Texas Commission on Environmental Quality Waste Permits Division Correspondence Cover Sheet

RE: Response to TECHNICAL NOD 1 New Registration No. CCR116
Coletto Creek Power LLC – Fannin, Goliad County
Industrial Solid Waste Registration No. 31911
EPA Identification No. TXD000836999
Tracking No. 27315444; RN100226919/CN605521988

Table 1 - NOD Summary and Response
 Registration No. CCR116 - Coledo Creek Power LLC
 Application Deficiencies - Technical NOD 1

Luminant
 Figure 1
**COLETO CREEK POWER
 STATION FLOODPLAIN MAP**
 PROJECT: 272 | DATE: MAY 2022 | BY: RCADARS | CHECKED: DBS
Bullock, Bennett & Associates, LLC
 Engineering and Geoscience
 Texas Registrations: Engineering L-8542, Geoscience 60127

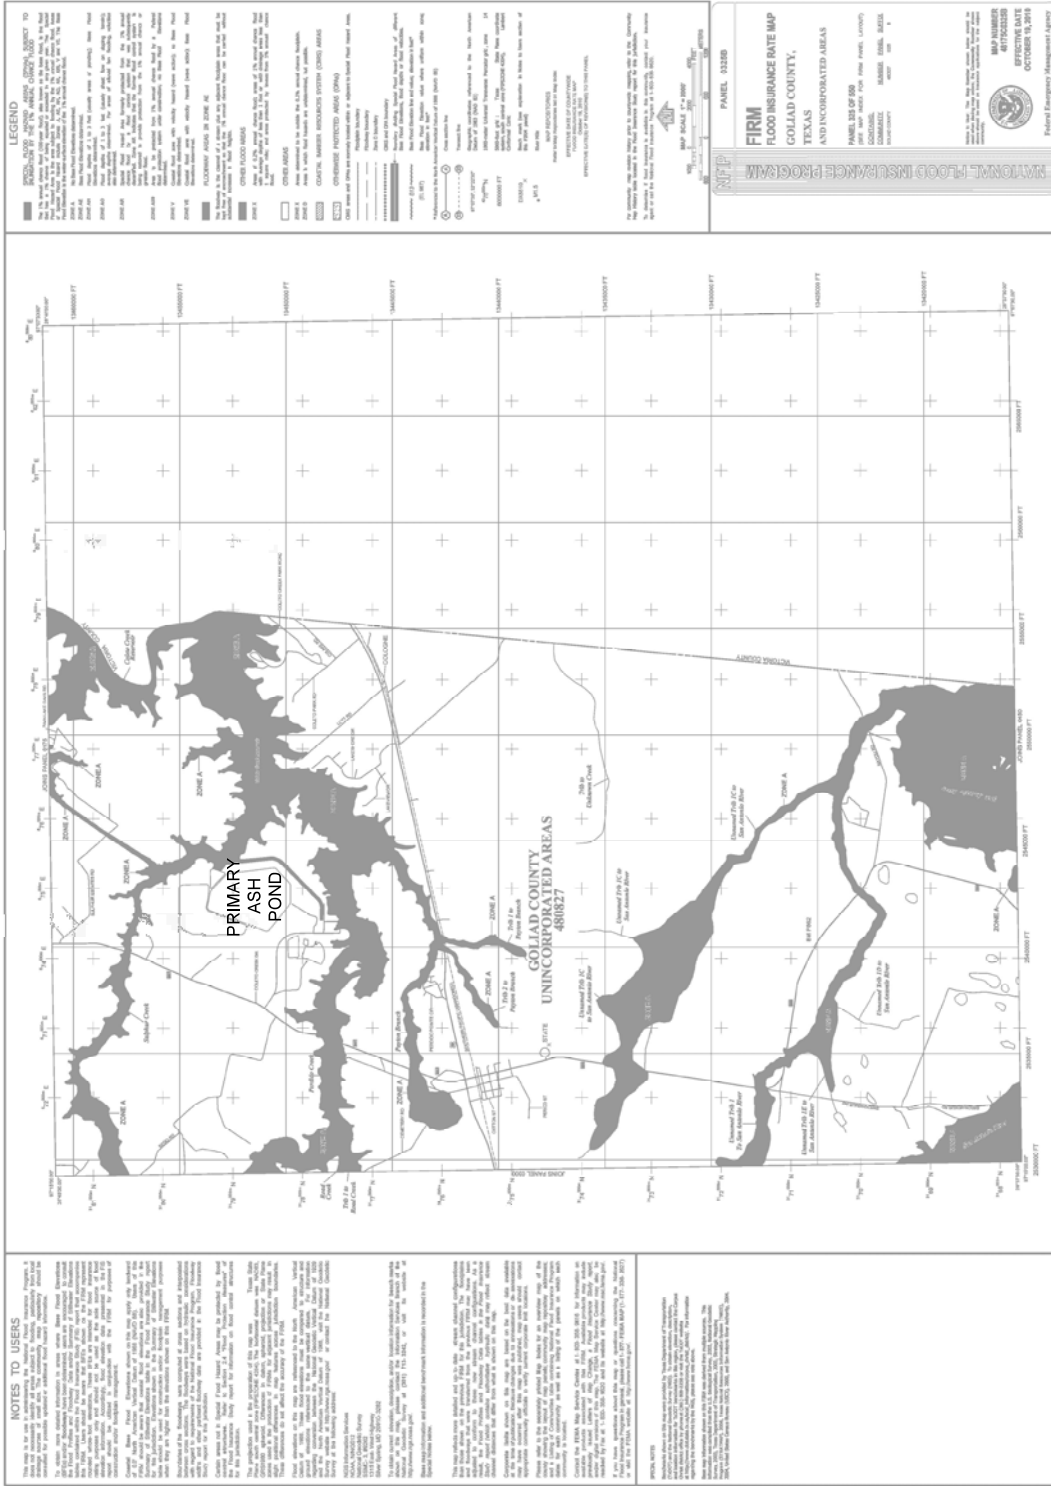
4	I. General Information	I.21		30 TAC 352.2; 40 CFR 257.52; 40 CFR 257.3-1; 40 CFR 257.3 2; and 257.3-3	Provide documentation to verify compliance with floodplains, endangered species, and surface water protection requirements.	Brief memo provided by Qualified Professional Engineer indicating compliance added to Appendix A. Comment indicating addition of memo inserted on page 6 under Item 21. Attachments and Tables list updated on page 18 to reflect addition to Appendix A.
5	II. Location Restriction and Geology	II.22	Appendix B	Application Instruction 30 TAC 352.601, 352.611, 352.621, 352.631, 352.641 40 CFR 257.60, 257.61, 257.62, 257.63, 257.64.	Provide supporting information related to fault areas, seismic impact zones, unstable areas, wetlands, and placement above the uppermost aquifer, or reference where this information is located in the application.	Included "Location Restrictions Assessment" by Bullock, Bennett & Associates (2018) in Appendix B. Comment indicating addition of document on page 6 under Item 22. Attachments and Tables list updated on page 18 to reflect addition to Appendix B.

As shown on Figure 1, the Coletto Creek Primary Ash Pond is not located within the 100-year floodplain as defined by the Federal Emergency Management Agency (FEMA). Therefore, this regulation does not apply to operation of the Primary Ash Pond.
